**Subject: Southern California Edison's Comments on the Commission's Draft Environmental Impact Report for the Ivanpah-Control (I-C) 115kV Project (A. 19.07-015)**

# Ivanpah-Control 115 kV TLRR Subtransmission Project

## DRAFT ENVIRONMENTAL IMPACT REPORT ~ SCE COMMENTS

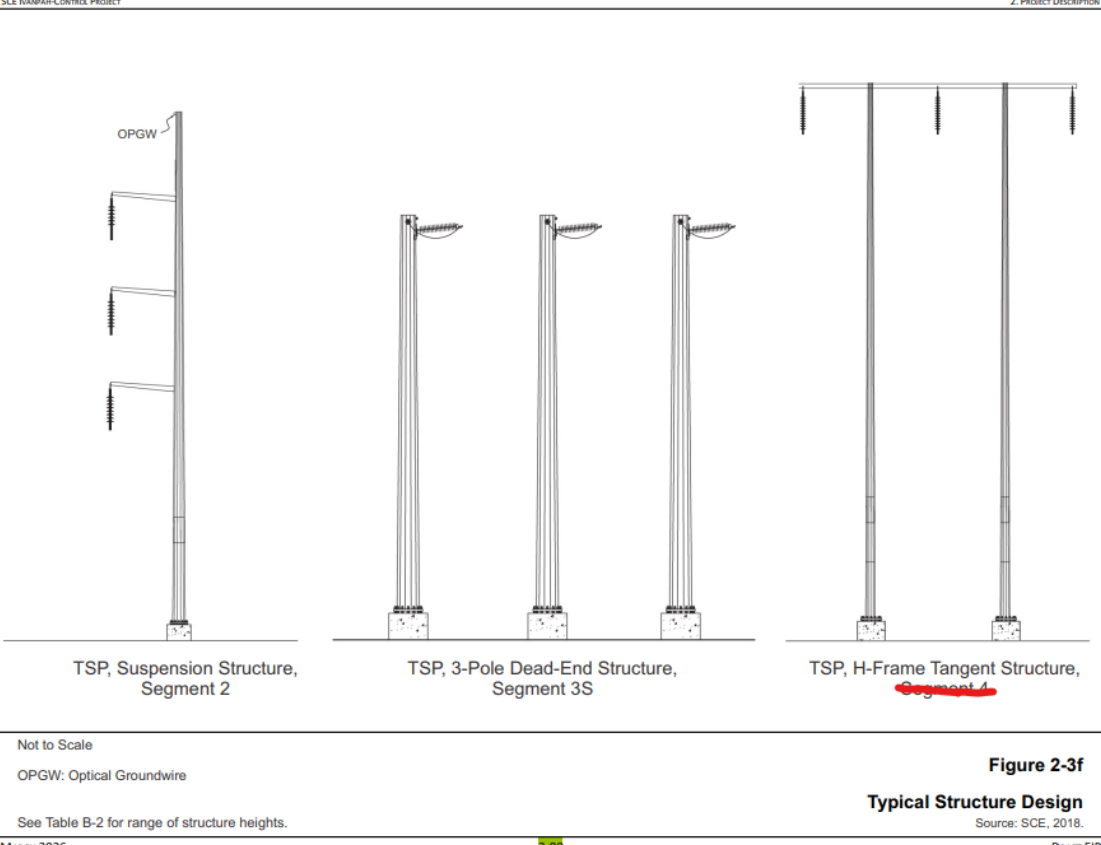
| Section  | Page   | DEIR Original Language   | SCE Recommended Language and/or Comment  |
|----------|--------|--|--|
| 2.9      | 2-80   | Figure 2-3f: TSP, H-Frame Tangent Structure, Segment 4.  | <p><b>Comment:</b> Segment 4 has been removed from the project scope. Please remove Segment 4 wording under the structure label.</p> <p><b>Recommended language to Figure 2-3f</b> (see red-line). Please cross out the word Segment 4.</p>  |
